WELLS & ASSOCIATES, LLC

RE: Tilden Street PUD
Edmund Burke School Rerouting

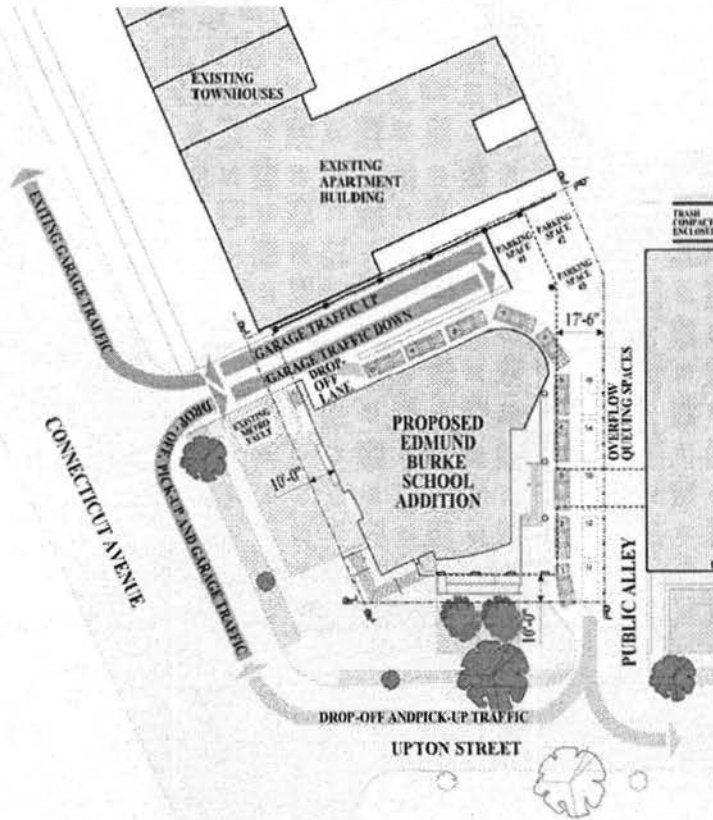
At the hearing before the Zoning Commission for Case No. 05-26 on June 5, 2006, the Commission questioned why there would be an increase in traffic at the intersection of Connecticut Avenue and Tilden Street as shown on Figure 3-1 on page 11 of our Traffic Impact Study submitted into the record. This increase would be caused by the implementation of a Traffic Management Plan (TMP), which would require all School traffic to utilize the Connecticut Avenue/Tilden Street intersection instead of alleys connecting Tilden Street to Upton Street.

As a follow up to the Tilden Street PUD hearing on June 5th, we are providing additional information regarding the rerouting of Edmund Burke School site trips as it relates to the Tilden Street PUD Traffic Impact Study. Specifically, attached you will find a graphic which shows the School's proposed morning drop-off plan and a graphic which shows the School's proposed afternoon pick-up plan. Additionally, the School's TMP indicates the following for the morning drop-off and afternoon pick-up plans:

In summary, the rerouting was required for two primary reasons. First, the School would have a right-in/right-out access on Connecticut Avenue, which it did not have previously. And second, as outlined in the School's TMP, public alleys would no longer be used by School traffic. Therefore, additional traffic would utilize the Connecticut Avenue/Tilden Street intersection, as analyzed in the Tilden Street PUD Traffic Impact Study, since inbound School traffic would no longer use 29th Street and inbound/outbound School traffic would no longer use the Upton Street – Tilden Street alley.
